SLR Project No.: 184398

RE: Bridge Farm RMA 243124 – Letter of Objection

Date: 22 November 2022
Application: 223455

PROJECT: Land north of the A4, New Bath Road, Twyford				CLIENT: David Wilson Homes	
DRAWING TITLE: PROPOSED MINOR SECONDARY SITE ACCESS NEW BATH ROAD GENERAL ARRANGEMENT AND VISIBILITY SPLAYS				PART OF vectos. SLR	
DRAWN: SCJ	CHECKED: jb	DATE: 01/03/23	SCALES: AS SHOWN @ A1	DRAWING NUMBER: 184398-PD14	REVISION: C

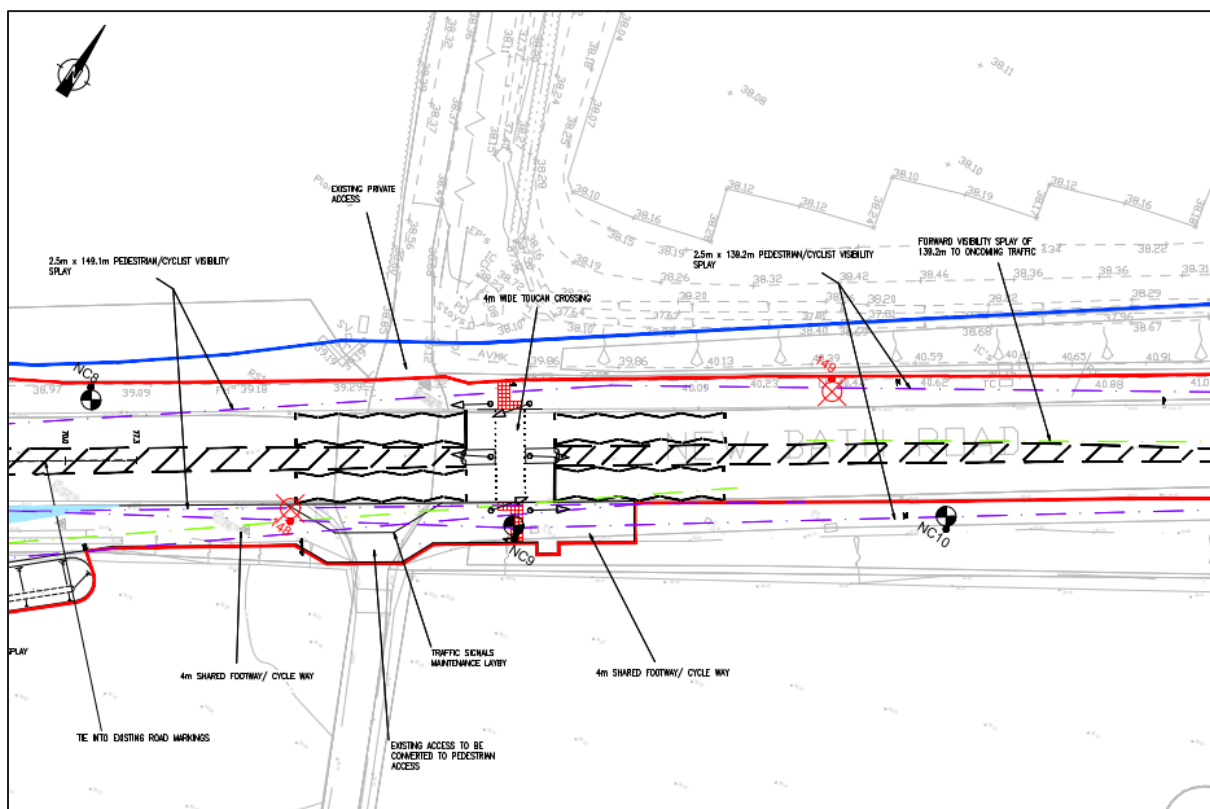
You will note when reviewing this drawing that the access was designed having regard to the location of a Toucan crossing approved pursuant to the Bridge Farm outline consent (Ref: 212720). This crossing is shown in magenta lines and is located some 19 metres to the east of the existing access to Loddon Park Farm, which was shown as being upgraded on enclosed Drawing 184398-PD14 Rev C.

Somewhat surprisingly, and without any justification, the detailed access drawings submitted in support of RMA 243124 show this crossing being re-positioned from the location agreed at the outline stage. Perhaps more surprising is the fact that the crossing is now being shown in a location that directly conflicts with the secondary access that the Council's highways team approved with respect to application 223455, this is shown below:

Aside from resource that will be wasted delivering infrastructure, it should also be noted that there would be duplication of construction phases. This would unnecessarily prolong disruption along the A4, which you should be aware was something Wargrave Parish Council took a keen interest in.

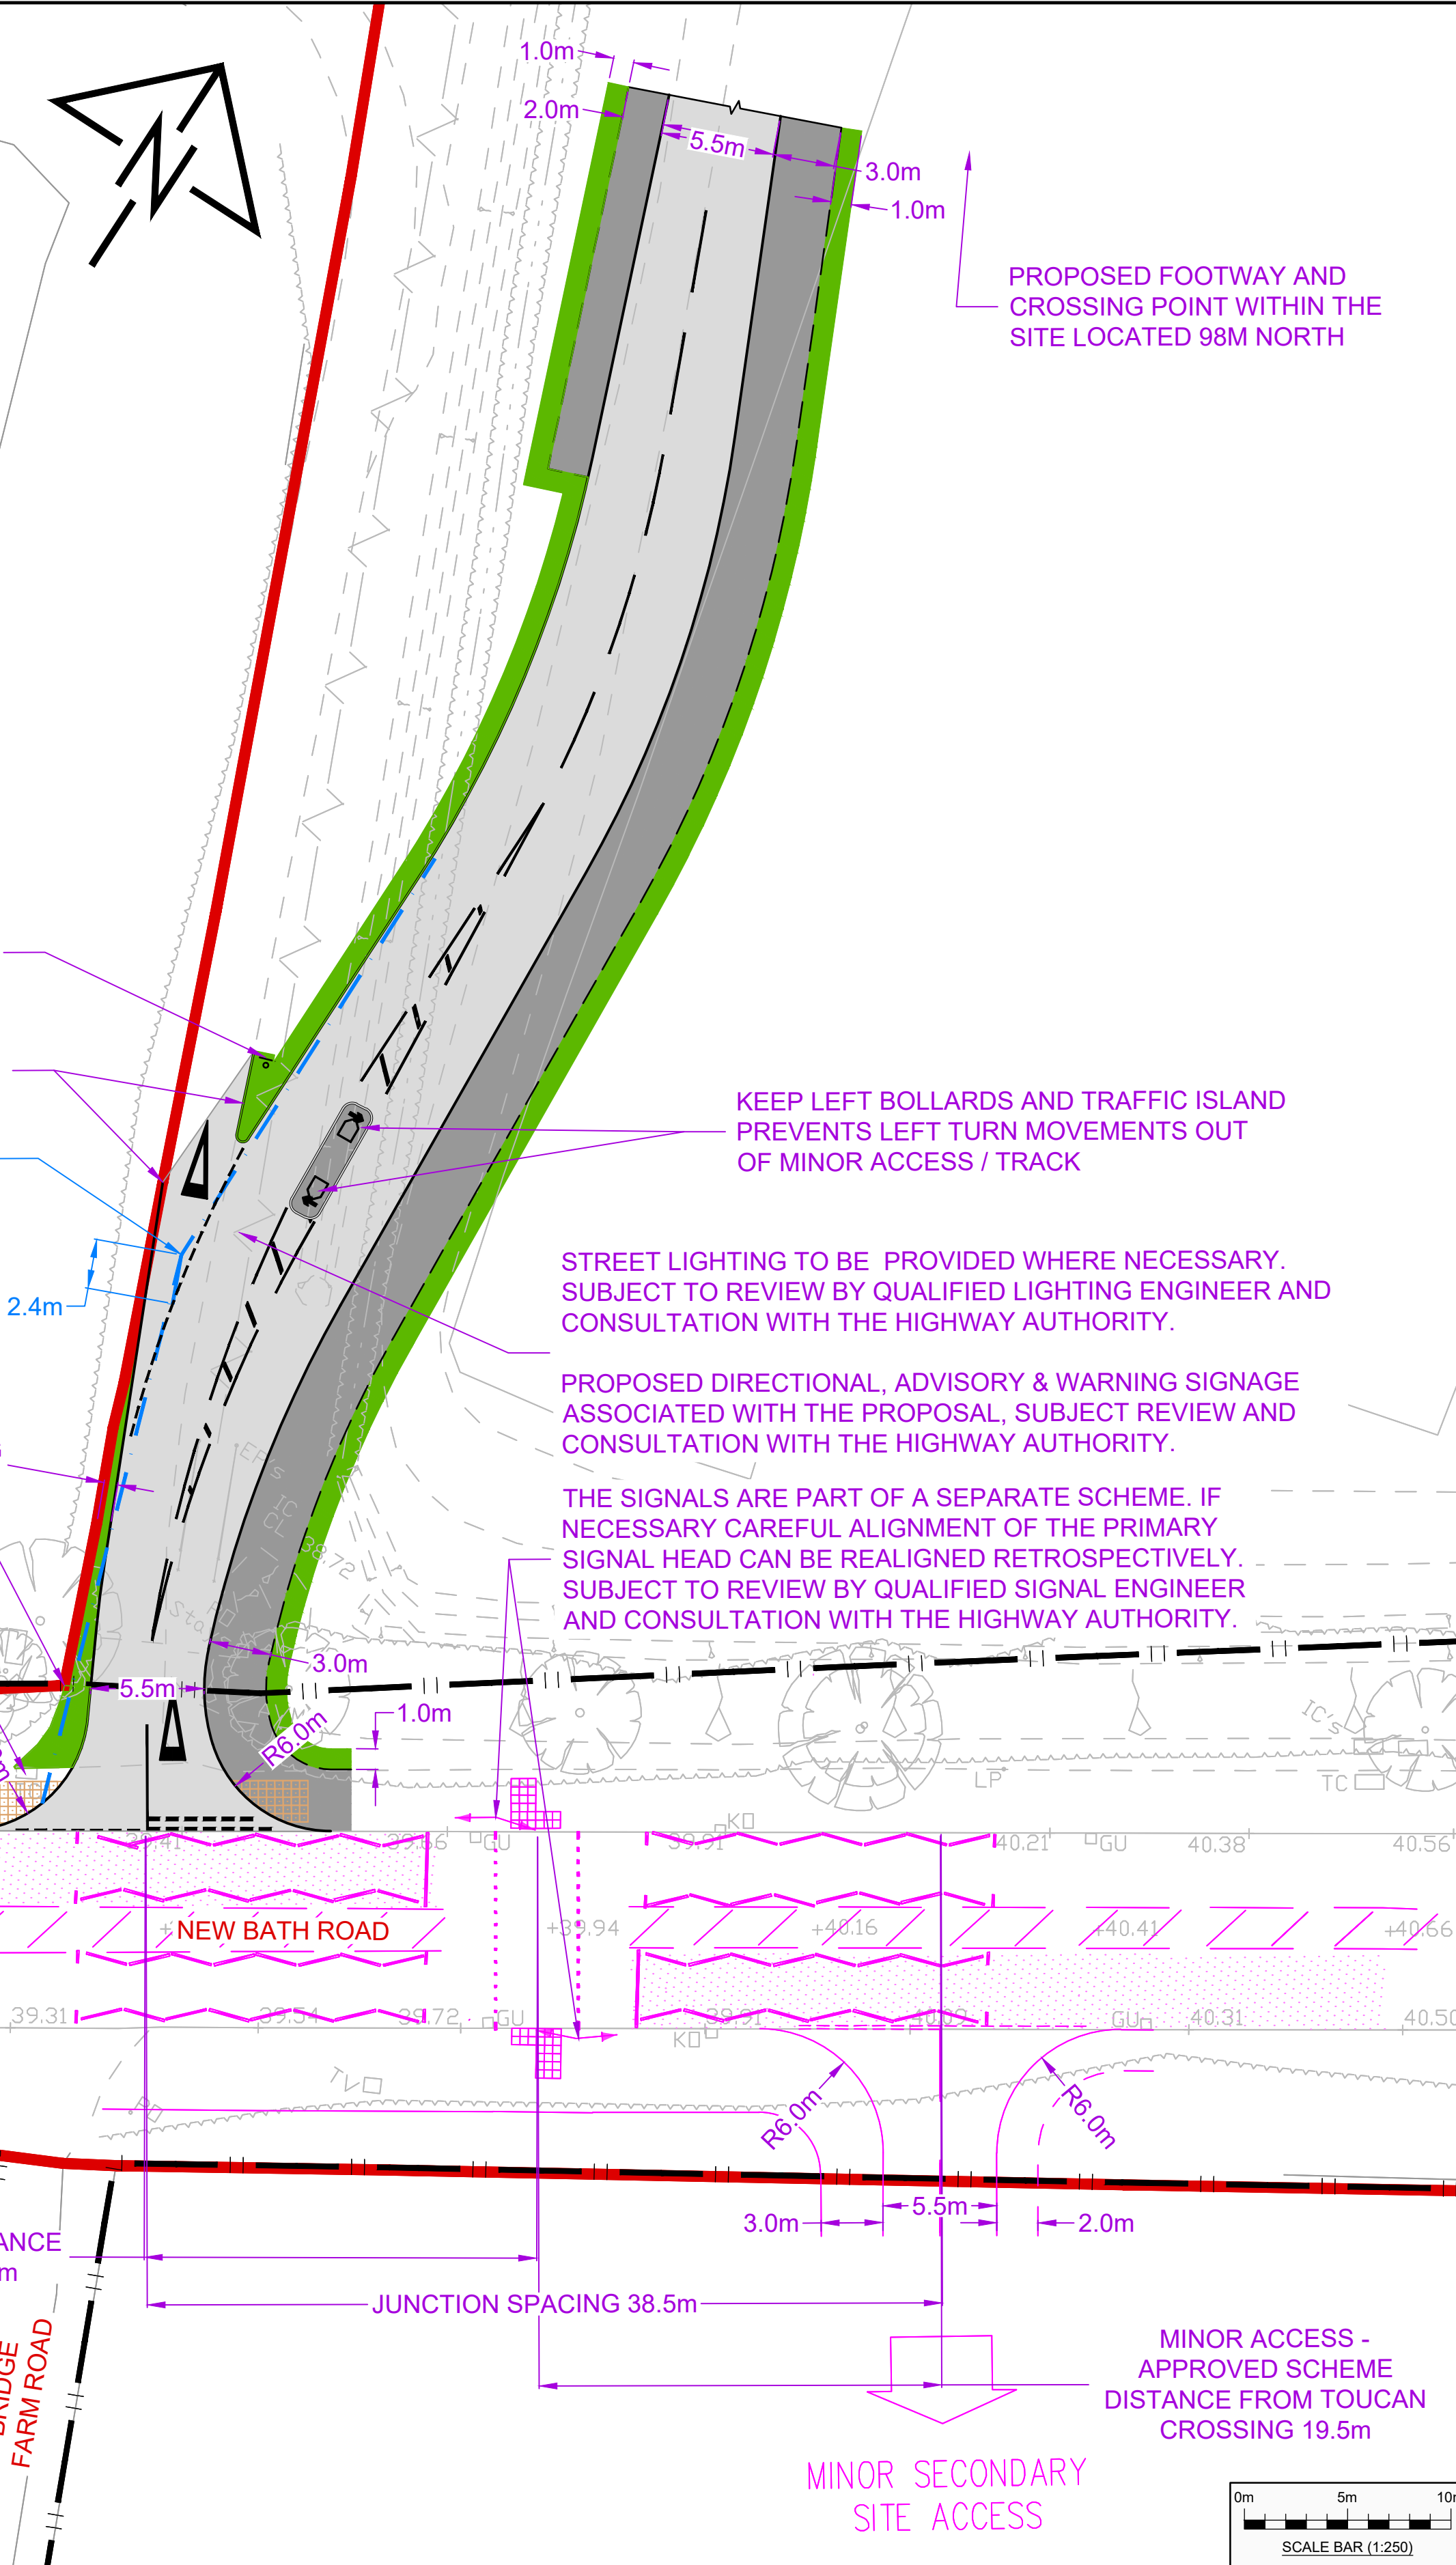
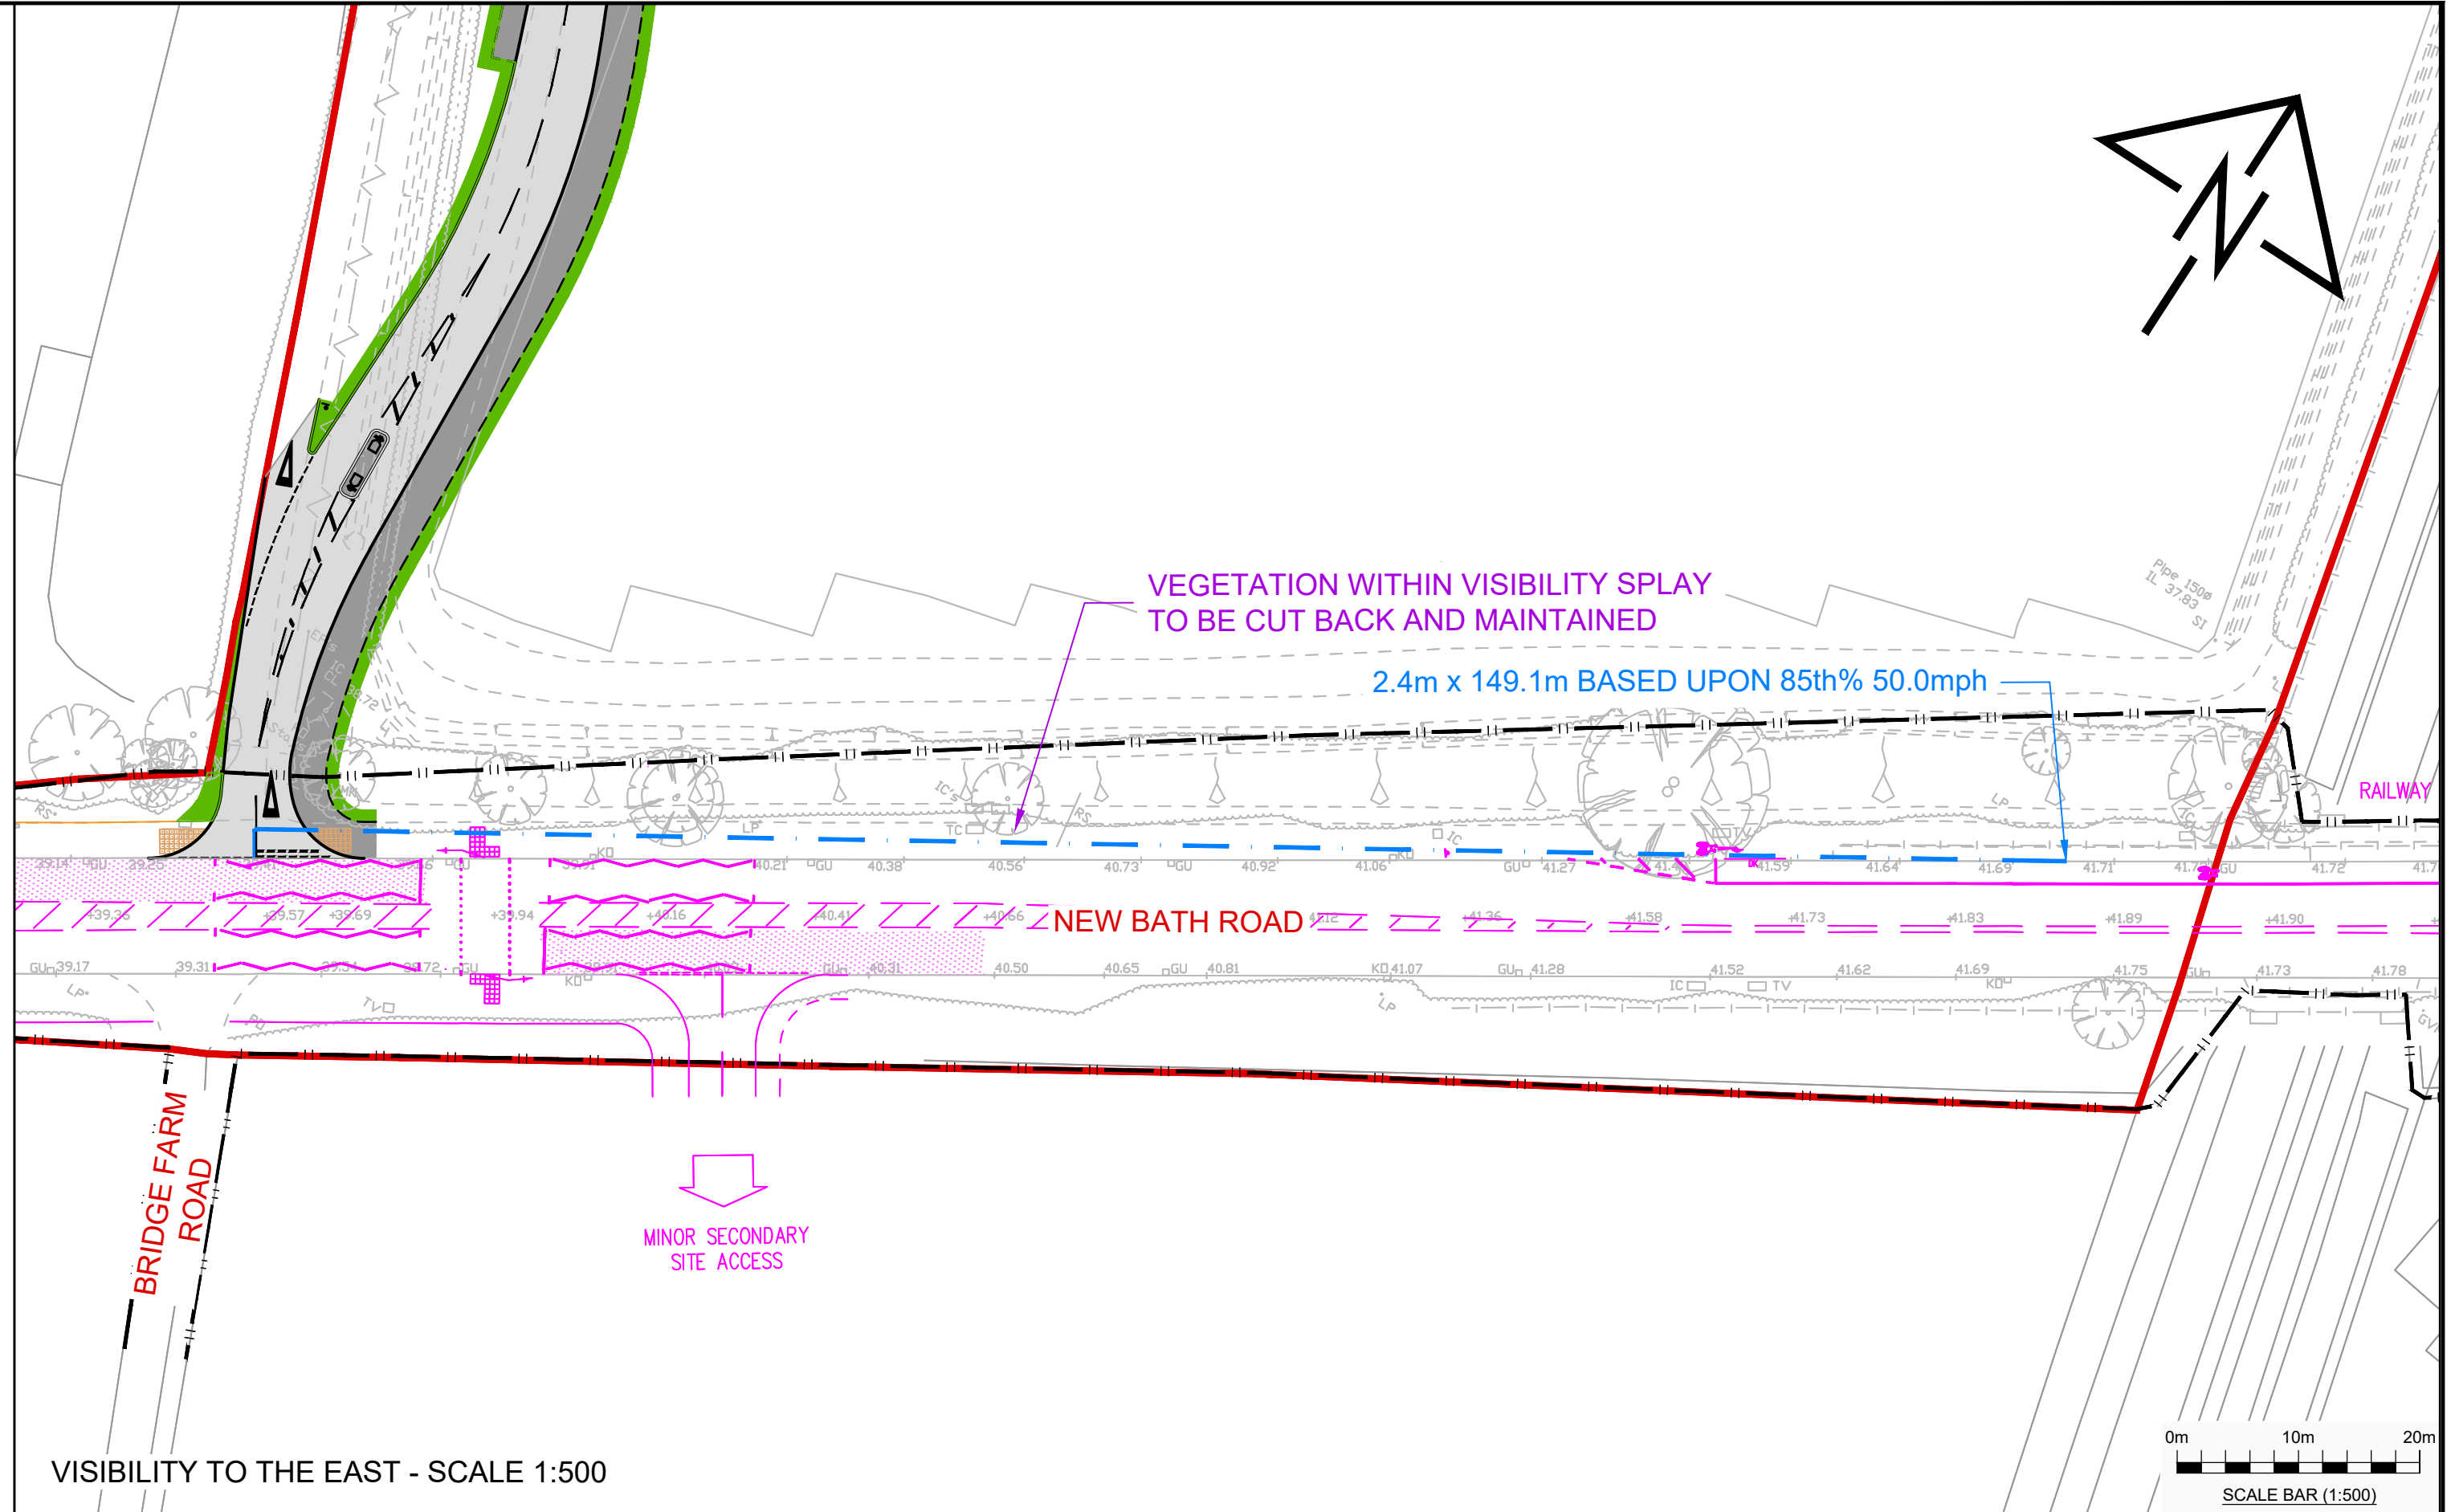
The access that is referred to in the extract from the final highway response refers to the proposal to upgrade an existing access to the site to provide access to at least 50 dwellings. A copy of this drawing is also enclosed.
